**Subject: Revised Corrective Measures Pre-design Investigation Results Report Revision
and Responses to Comments**

ArvinMeritor, Inc.'s Responses to EPA Comments Draft Corrective Measures Pre-design Investigation Results Report

Figure 4-1: Proposed Sludge Lagoon Cap

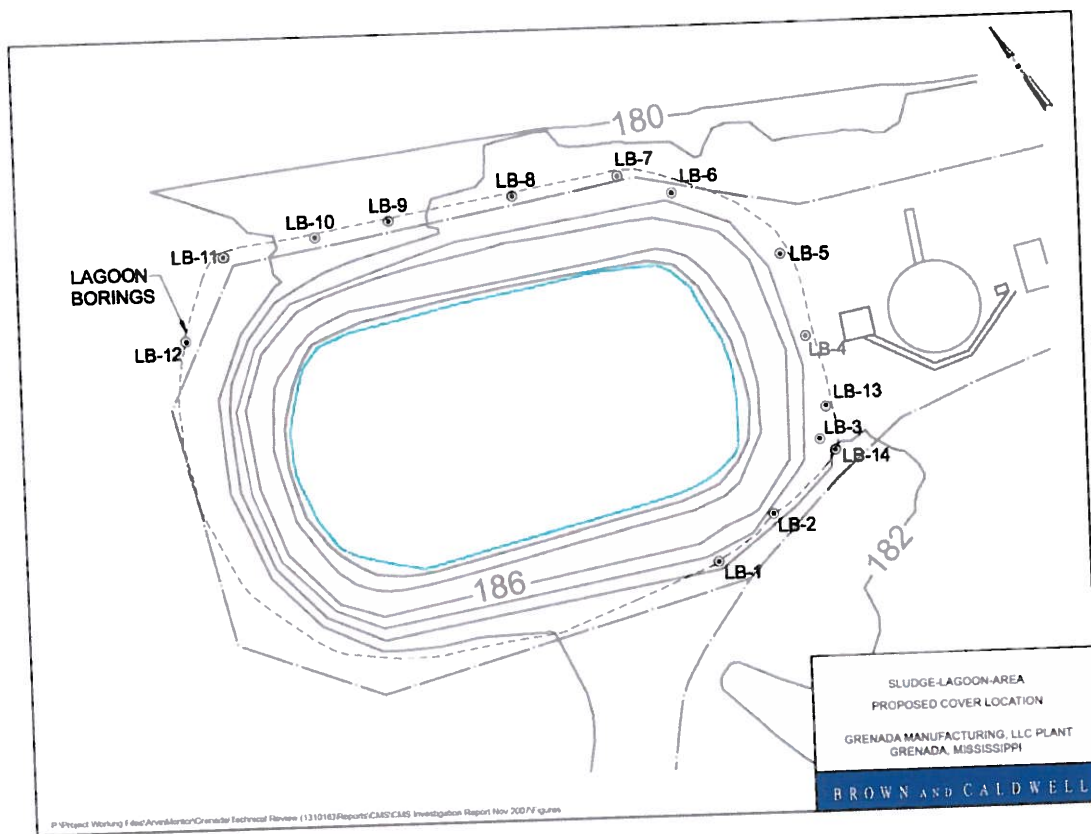
Section 8: *I agree with the summary of recommendations given here. With regard to your comment on Section 8.3 to further define the cap, it does need to be stated if it is an impermeable cap.*

Response: The plan is to design an impermeable cap to prevent/minimize infiltration through the stabilized sludge. Detailed design specifications will be provided in the Sludge Lagoon Closure Plan. The following text was added to Section 8.3, page 8-1.

"An impermeable cap design is planned that will likely include a 60-mL thick HDPE membrane, and a geocomposite drainage layer, 18 inches of common borrow soil, and 6 inches of soil to support grass growth. Detailed specifications and accompanying engineering drawings will be included in the Sludge Lagoon Closure Plan."
